*Swan and Canning Rivers Management Act 2006*

**DETERMINATION OF DEVELOPMENT APPLICATION**

FILE NUMBER	:	2020/2067
APPLICANT	:	Town of Bassendean
LANDOWNER	:	Town of Bassendean (Lot 51 and Lot 52) and Vested to Town of Bassendean (Lot 15525)
LAND DESCRIPTION	:	Sandy Beach Reserve – Lot 51 on Diagram 10690 (201), Lot 52 on Diagram 10690 (203) and Lot 15525 on Plan 40483 (Crown Reserve 18092), Bassendean
DEVELOPMENT	:	Construction of a nature-based playground and replacement of an existing ablution facility
VALID FORM 1 RECEIVED	:	2 September 2020
DETERMINATION	:	<b>APPROVAL WITH CONDITIONS</b>

- PROPOSAL : Construction of a nature-based playground and replacement of an existing ablution facility
- LOCATION : Sandy Beach Reserve – Lot 51 on Diagram 10690 (201), Lot 52 on Diagram 10690 (203) and Lot 15525 on Plan 40483 (Crown Reserve 18092), Bassendean

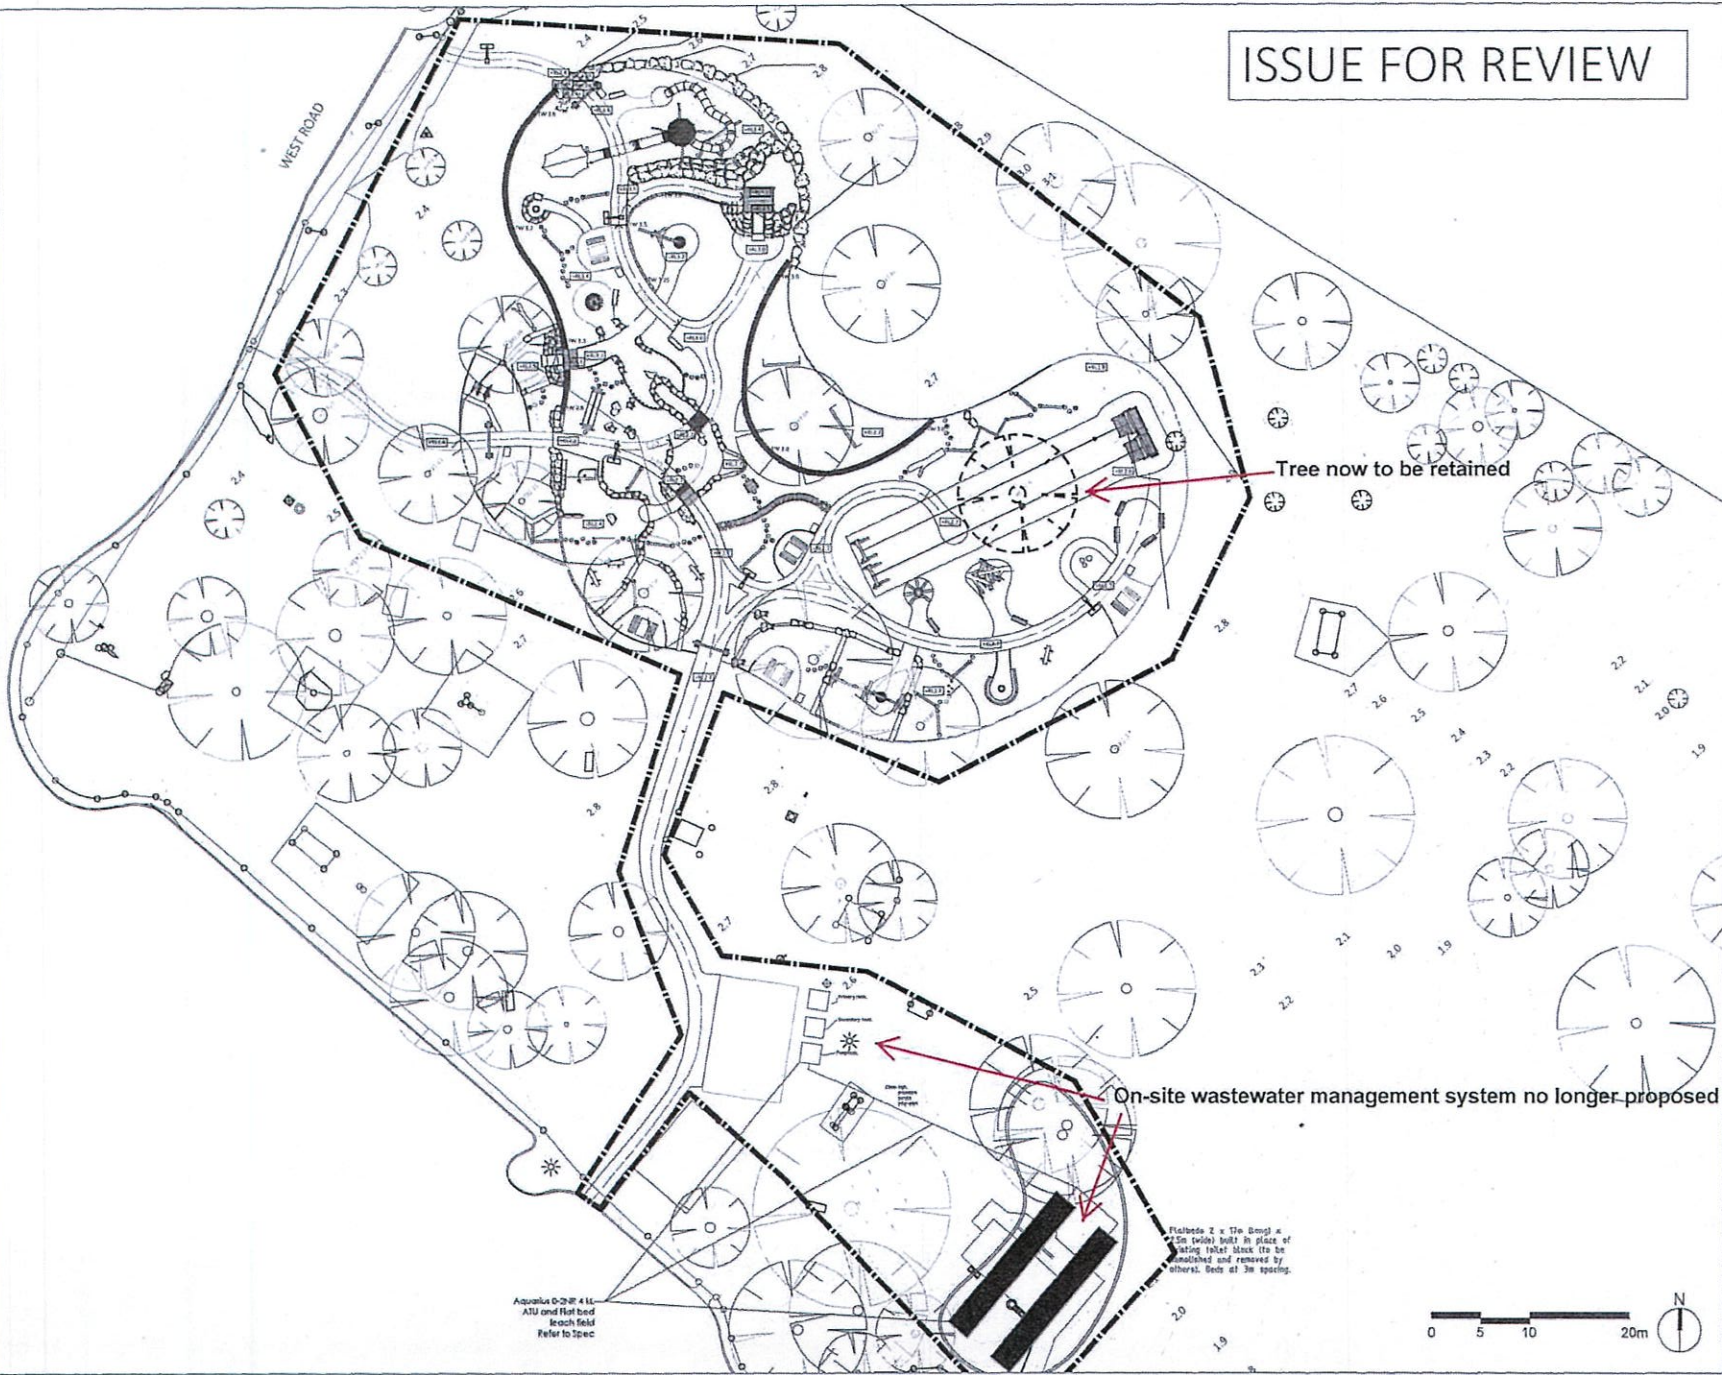
- 7.9 The provided plans indicate that one (1) tree (*Eucalyptus gomphocephala* – Tuart) will be removed from the development area as it is located within the footprint of the proposed flying fox. However, the Town has advised that it is seeking to amend the plans to ensure the Tuart tree is not removed as a result of the development. This can be achieved through the placement of a condition and an associated advice note, requiring the Town to submit finalised plans.

Tree now to be retained
